DEVELOPMENT DETERMINATION PANEL MEETING

WEDNESDAY 11 DECEMBER 2024

3.0	DEVELOPMENT DETERMINATION PANEL REPORTS	4
3.1	Mod2024/0547 - 33 Beatrice Street CLONTARF - Modification of Consent No.DA2021/2661 granted for alterations and additions to a dwelling house including a swimming pool	4

APPLICATION FOR MODIFICATION ASSESSMENT REPORT

Figure 1: Shadow diagram for 12pm, showing the proposed and existing overshadowing.

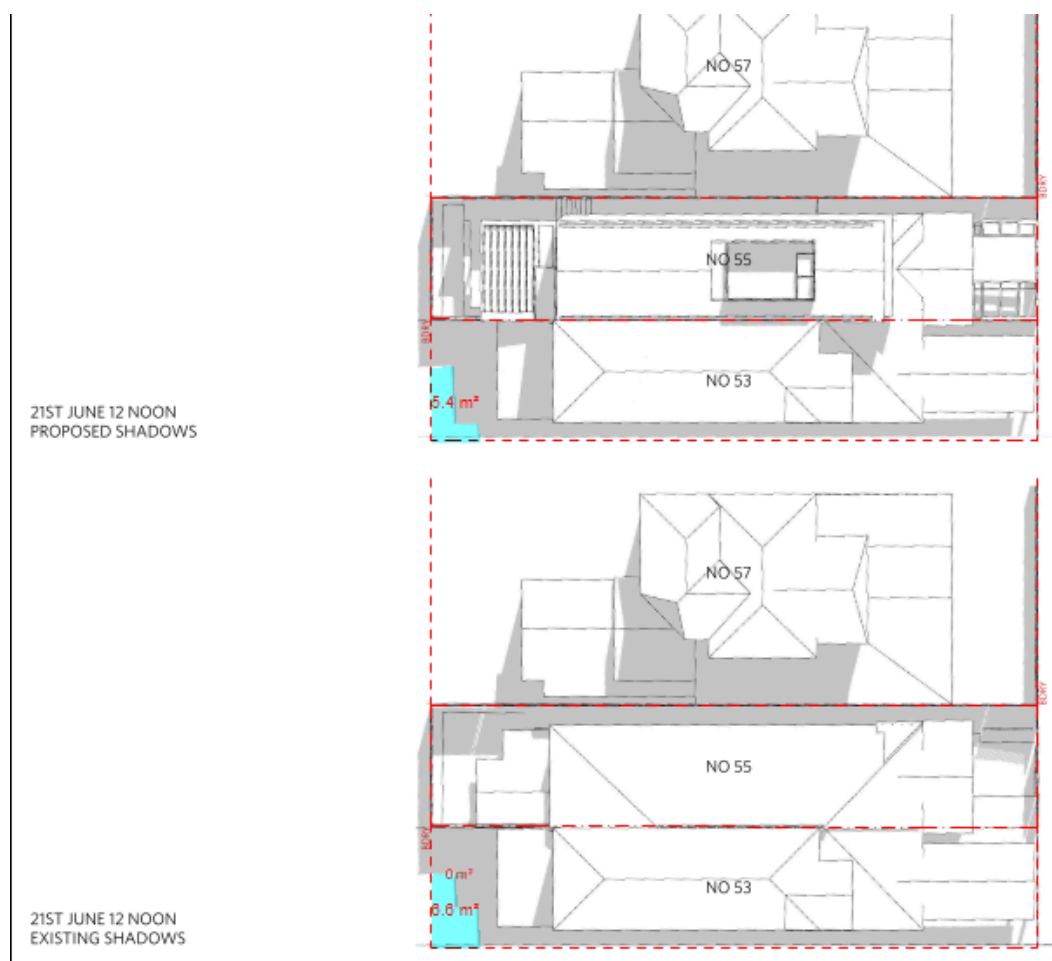
There is no change to the overshadowing at 9am and 3pm. At 12pm the proposal results in a lost solar access but as shown in figure 1, it is less than 1/3 of the solar access that is received.

Figure 3: Ground floor plan showing front, side and rear boundary setbacks.

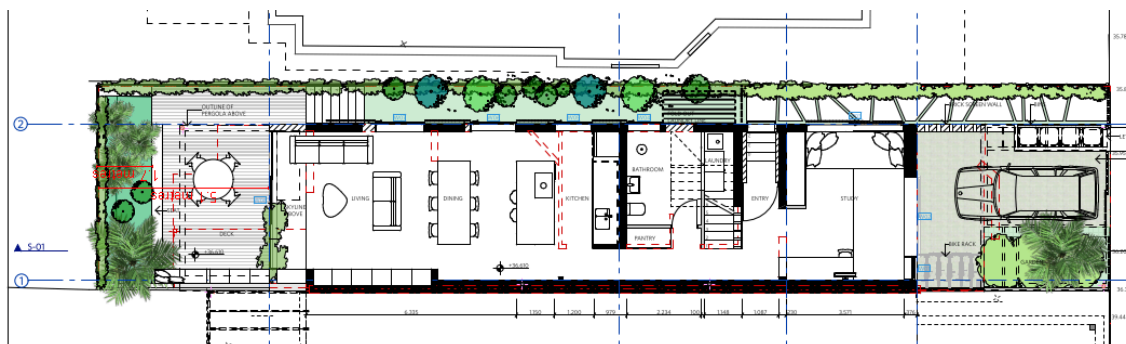
Ground floor: 5.1m (36.3% variation)

Figure 4: First floor plan showing front, side and rear boundary setbacks.

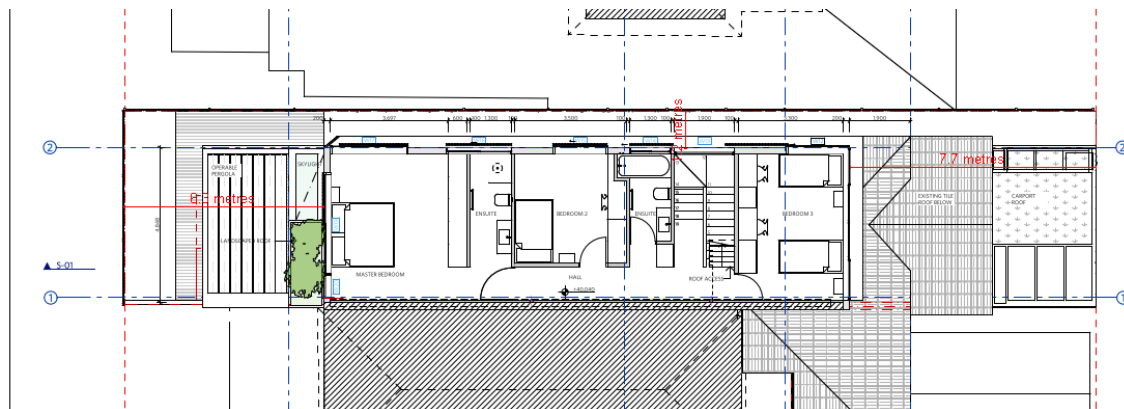
First floor: 6.3m (21.2% variation)

Figure 6 – amended eastern / front elevation. The increased first-floor front setback, retention of the gable roof and part of the hip roof achieve a more recessive first-floor addition and increased compatibility with the adjoining semi-detached dwelling

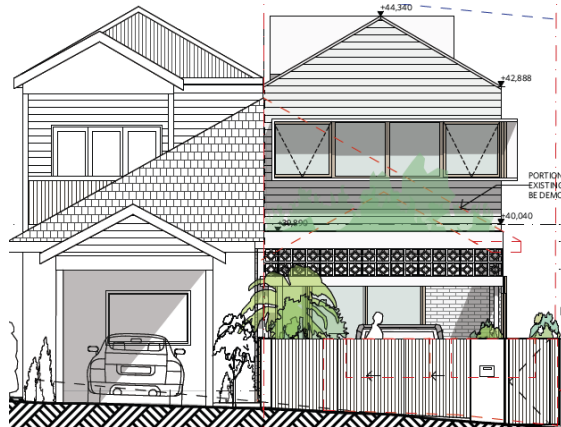
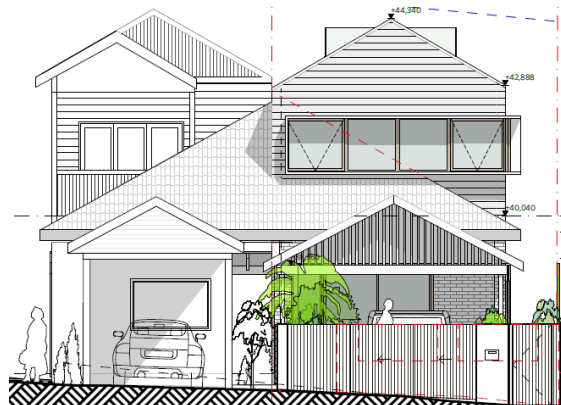
Figures 5 and 6 below show a comparison between the original and amended designs.

The proposal will not result in any inappropriate environmental impacts on the adjoining land in relation to solar access, privacy, view sharing, and visual intrusion.

Figure 1. Applicant's illustration of the proposed building height breach as measured from existing ground levels.

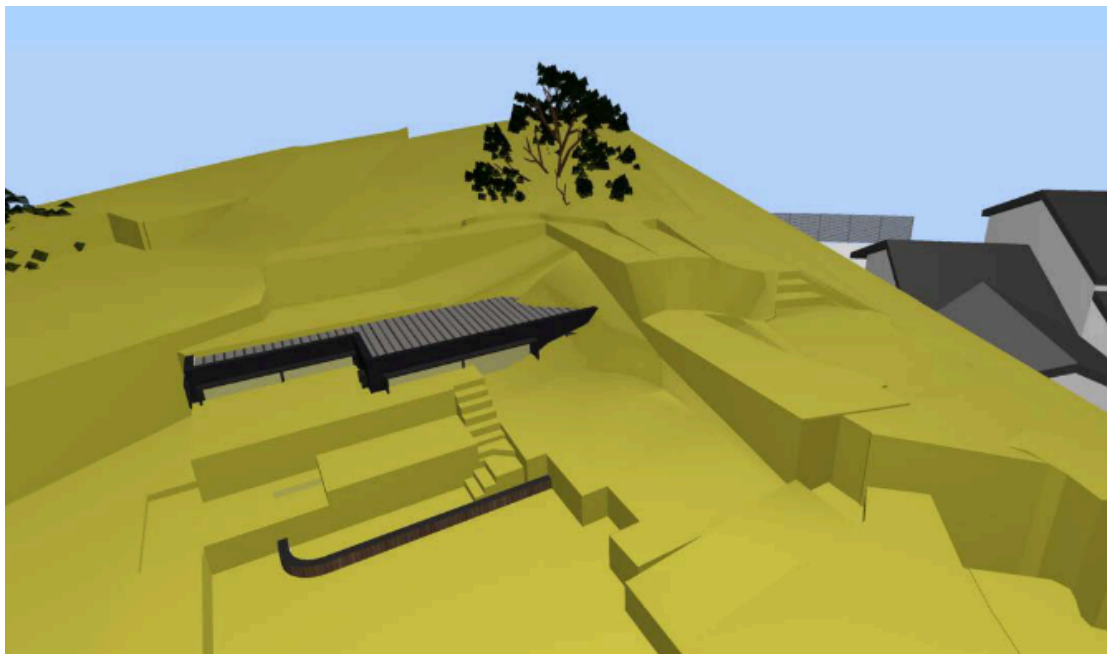
The above height plane diagram is not certified, however the portions of buildings projecting above the

height plane are generally in alignment with Council's assessment, and are presented in a more practical format than a two dimensional sectional drawing. On that basis, the diagram is included for illustrative purposes. Figure 2 below illustrates Council's calculation of the proposed maximum building height breach.

Figure 2. Council calculation of maximum building height breach - 9.4m

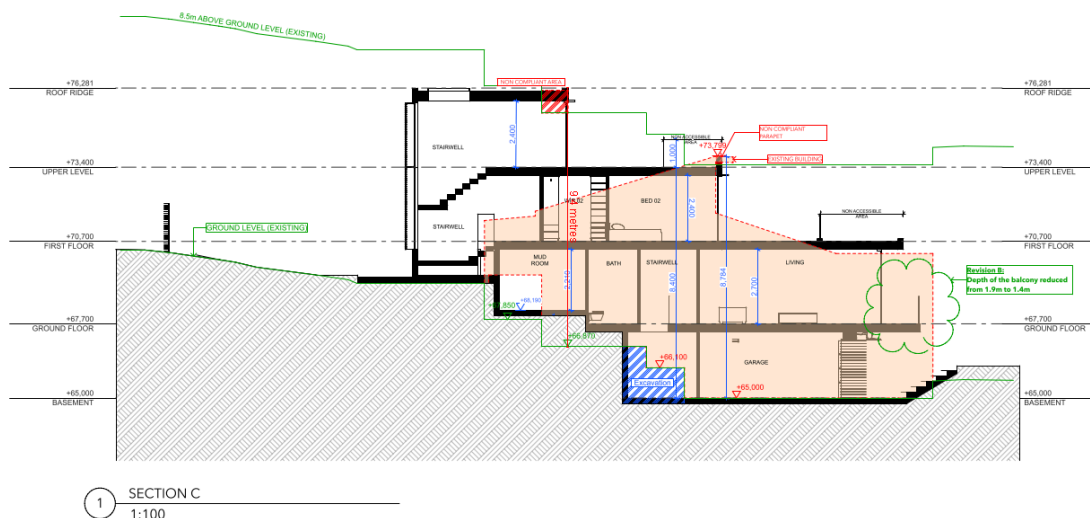
Proposed: 9.4m

Percentage of Variation: 10.59%

Figure 3. Proposed wall height breaches at the southern elevations shown shaded red

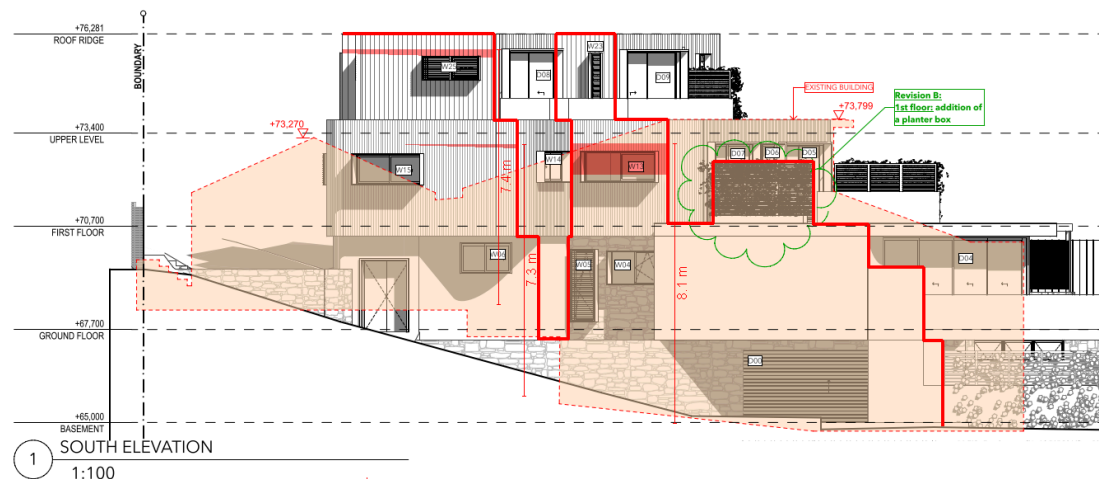
The proposed southern elevation has a maximum wall height of 8.1m at the first floor level and 7.4m at the upper level. The non-compliant wall areas are illustrated on Figure 3 below.

- As the alignment of the southern elevation plan is not parallel to the southern side boundary, various areas of the rear (eastern) walls are visible on the southern elevation plan. For clarity, south facing walls are those below the red line overlaid on the Figure 3, while rear (east) facing walls are those above the red line.
- The control specifies that the wall height is to be measured to the existing ground level. As such, the wall heights shown on Figure 3 are measured to the surveyed ground levels at the point below each wall.

Figure 4. Southern elevation building envelope breaches shaded red.

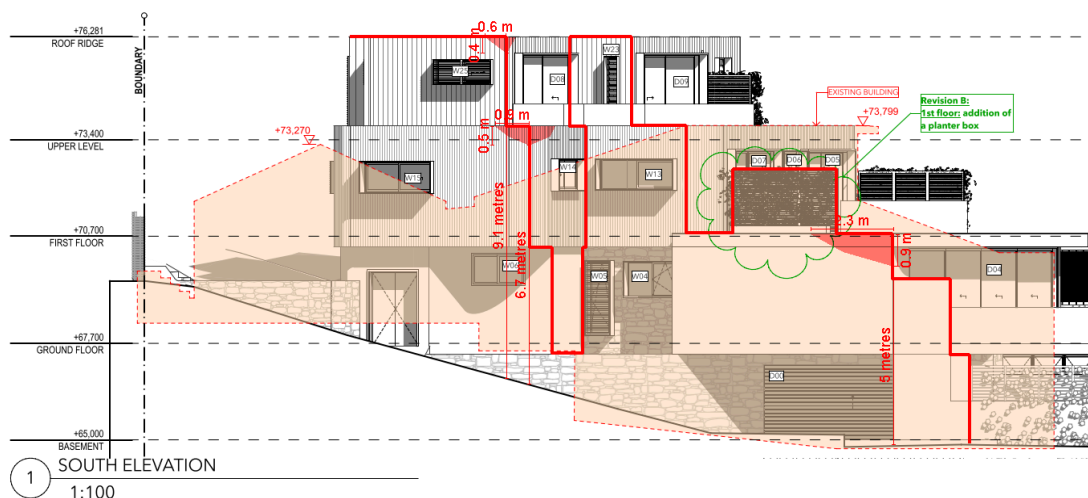
Note: As the alignment of the southern elevation plan is not parallel to the southern side boundary, various areas of the rear (eastern) walls are visible on the southern elevation. For clarity, south facing walls are those below the red line overlaid on the above Figure 4, while rear (east) facing walls are those above the red line.

Image 1: Section showing building height breaching elements

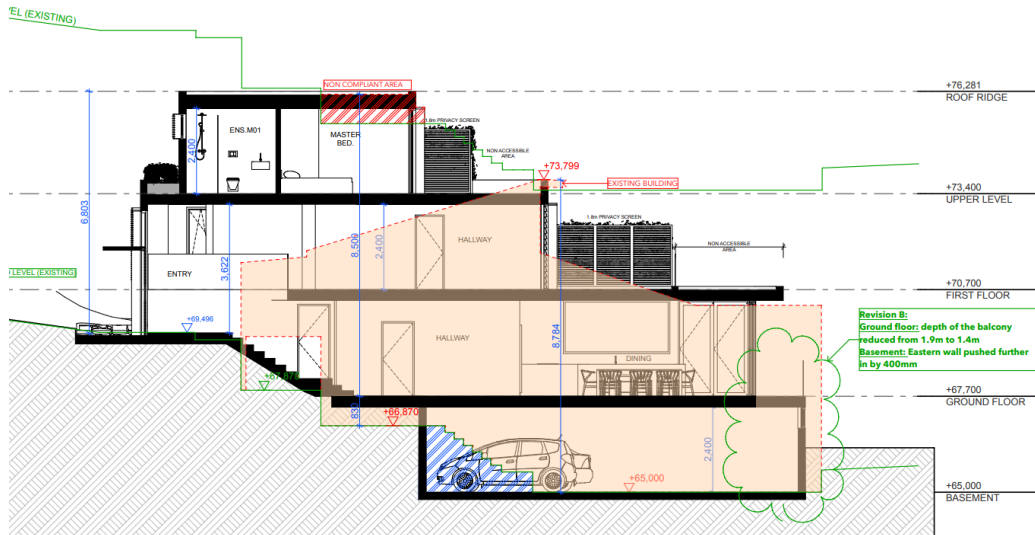
When measured from the existing basement ground level to the top of the eastern edge of the upper level the building height measures 8.784m which is a variation of 284mm or 3.34%.

We note that the previously disturbed levels of the site within the footprint of the existing building significantly distorts the height of buildings development standard plane overlaid above the site when compared to the topography of the hill.
